## **ADDENDUM #2**

### **Rye City School District**

***Issued: 2021-02-05***

**This Addendum No. 2 forms part of the Contract Documents and modifies the original bidding documents dated, January 19, 2021.**

SEAL & SIGNATURE	DATE:	11/07/19
	PROJECT No:	9200
	DRAWING BY:	BGA
	CHK BY:	BGA
	DWG No:	E2-304

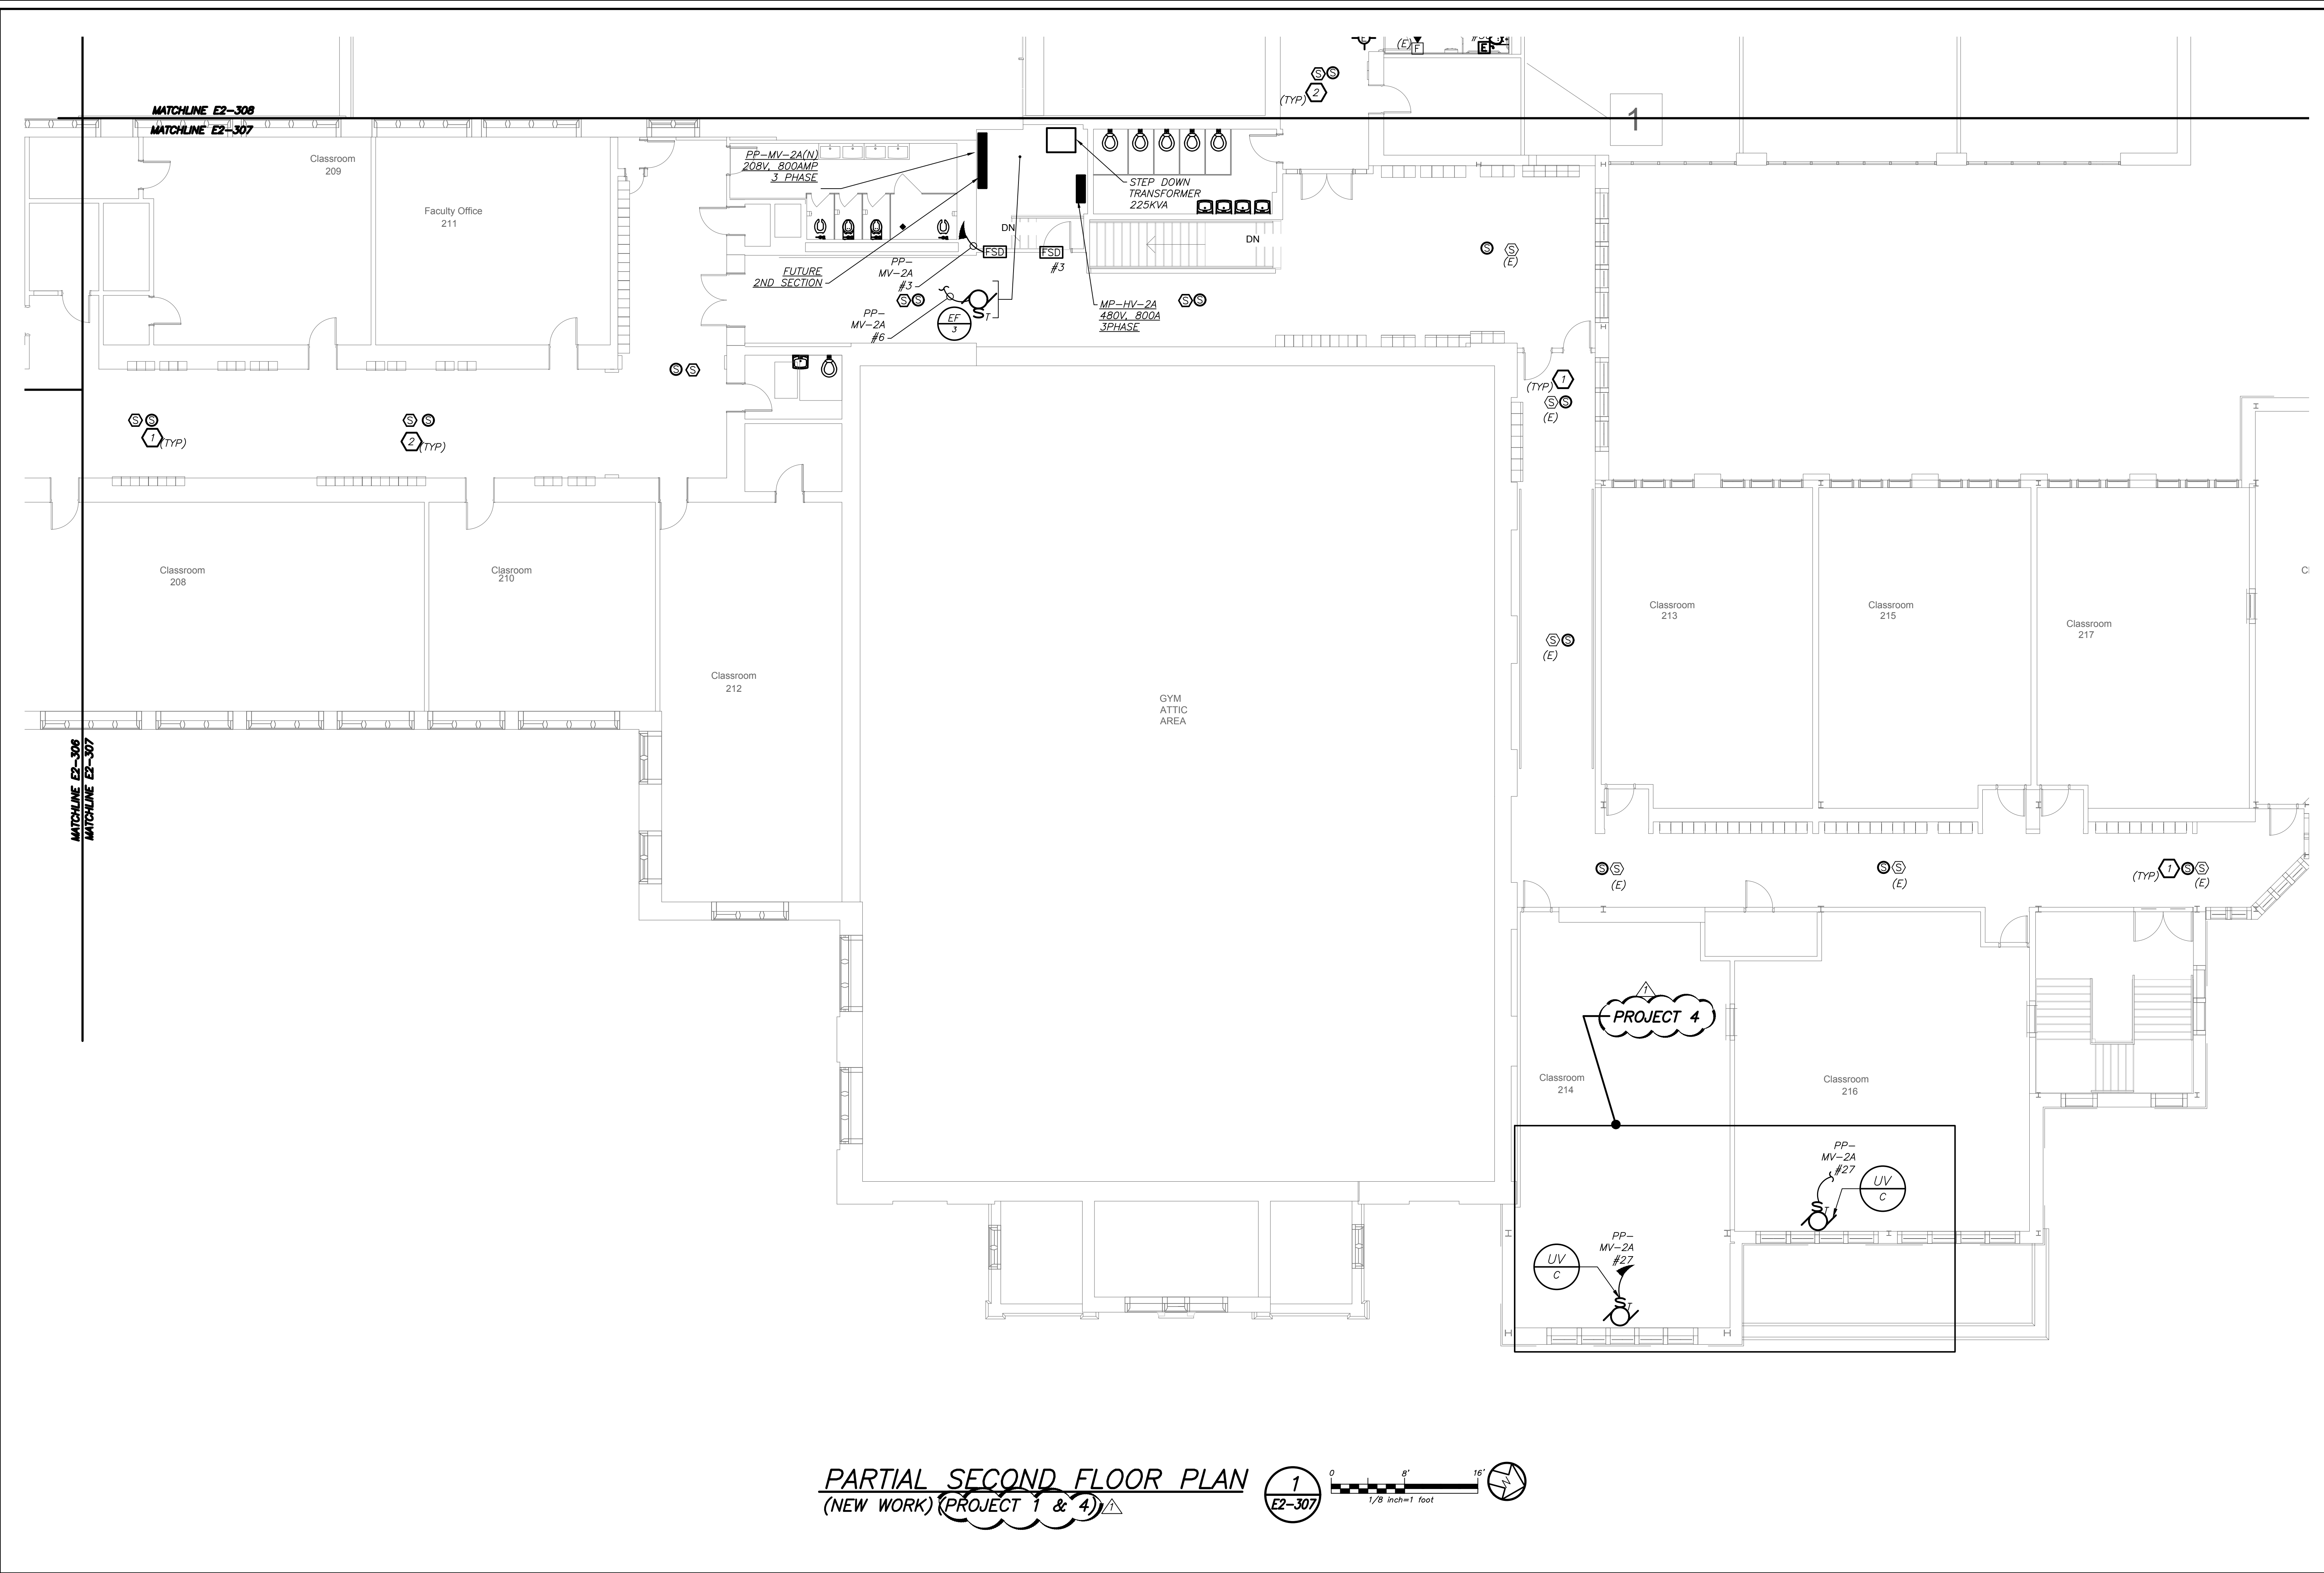
- a. Revised to show added lighting scope in corridor.
7. Drawing E2-304 Partial First Floor Power and Fire Alarm Plan
  - a. Revised to include power for ejector pump in ILAB.

EXTERIOR POWER PLAN (NEW WORK) (PROJECT 4) 1 E2-312

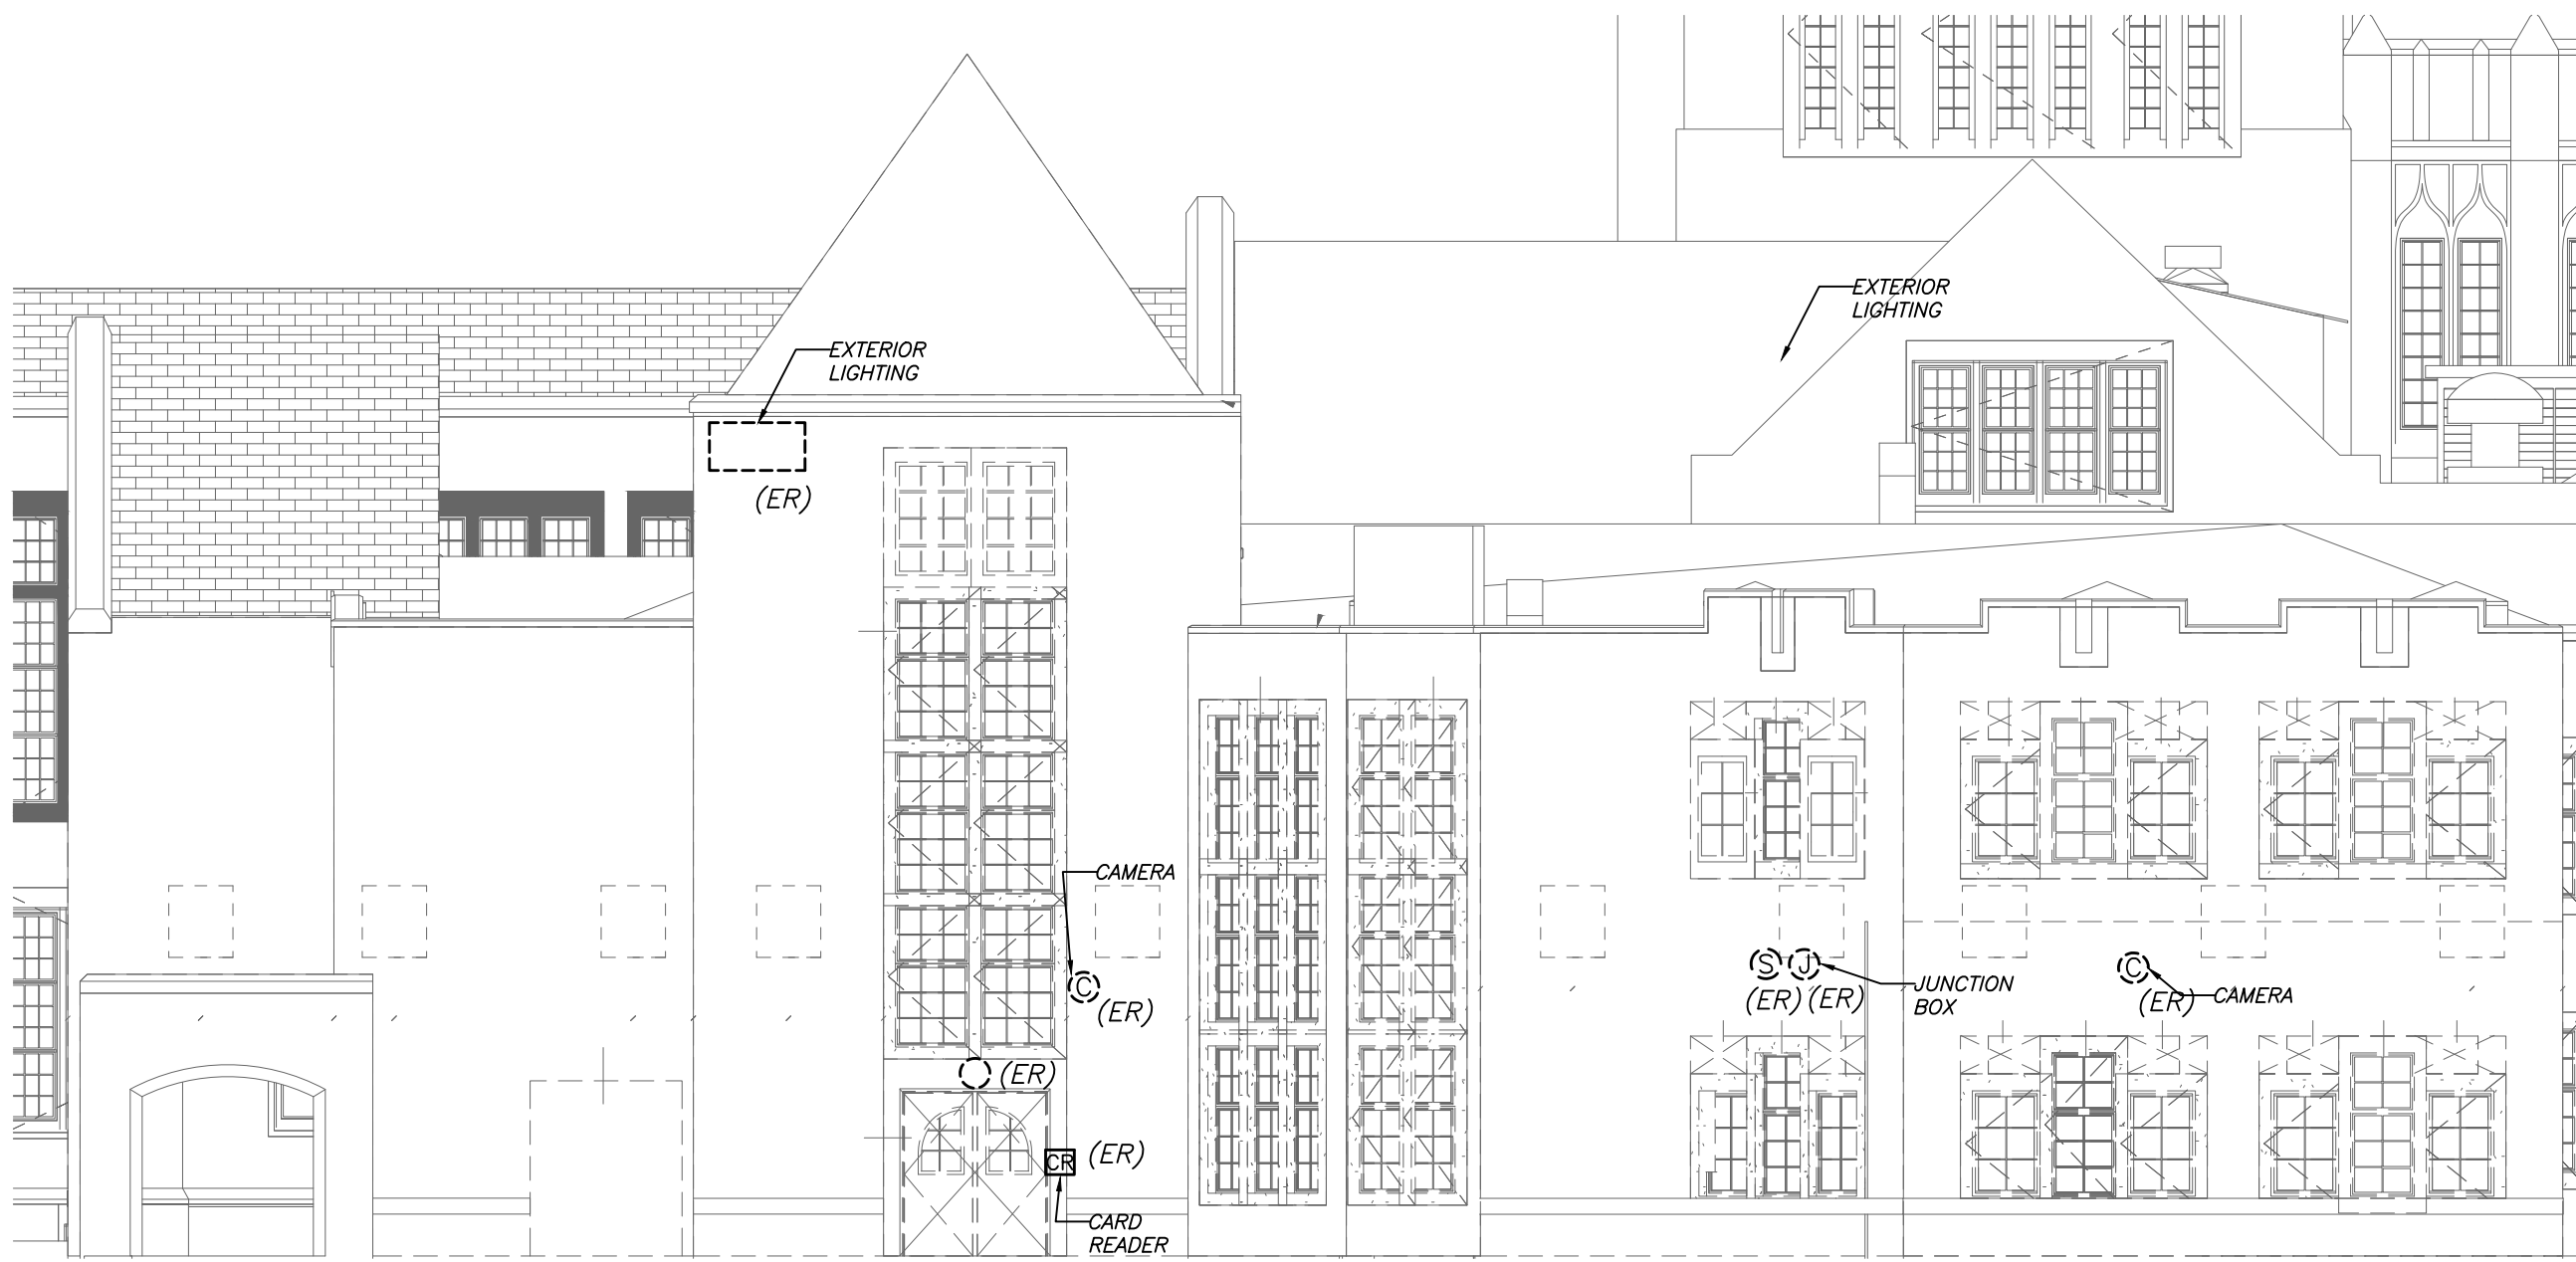
11. Drawing E2-312 Exterior Plan
  - a. Revised to include exterior electrical work as Project 4 instead of Project 4A.
12. Drawing E2-601 High School & Middle School Electrical Schedules
